Service Info

MF / Landini** - 228 0003 15 - 280/280 TGU6

New design / Neues Design / Nouvelle conception / Nuevo diseño / Nuovo disegno

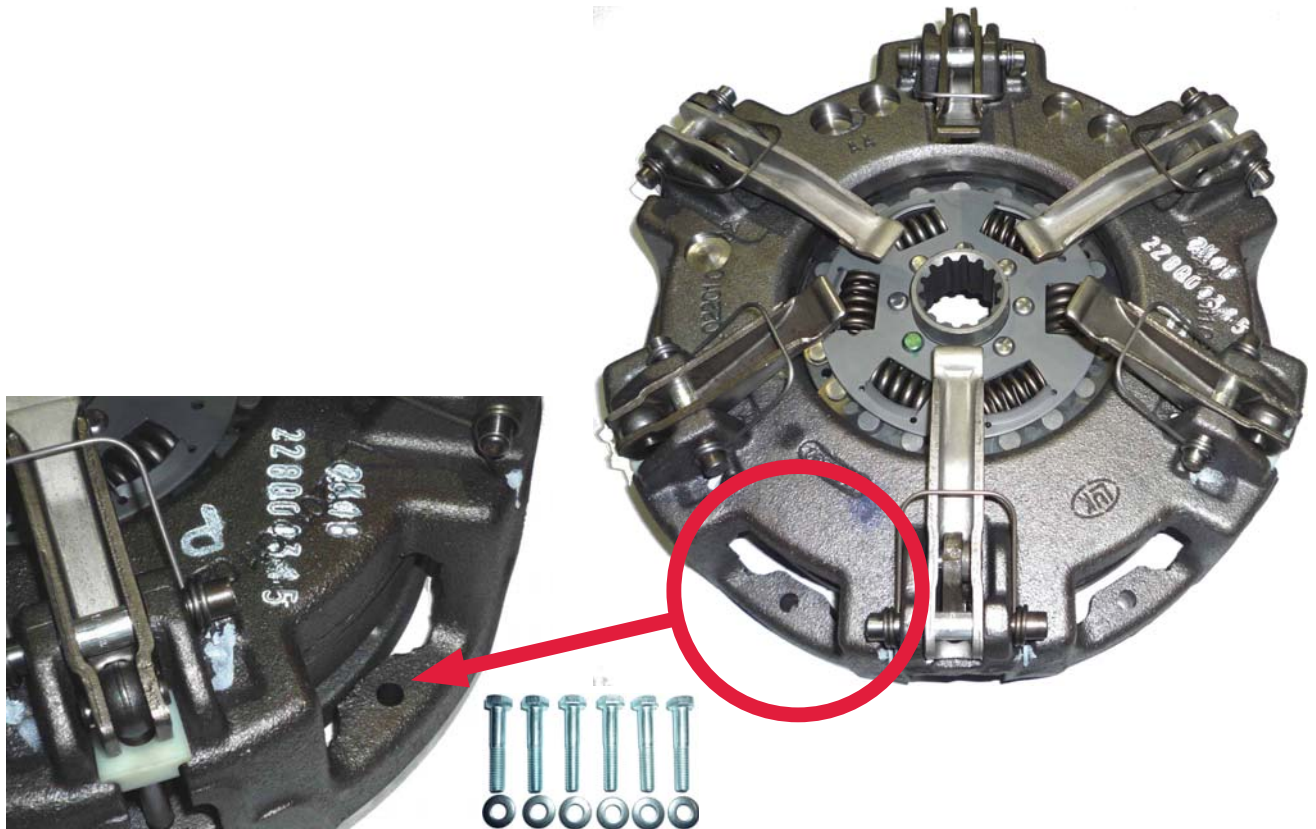
This new design utilises the latest clutch technology, using a vented housing for improved cooling and heat dispersal.

**Fully interchangeable with existing clutches with no modifications required to vehicle or flywheel.
New fixation bolt set 6 x M8 x 1.25 x 50mm is supplied with new designs to accommodate the lower housing.**
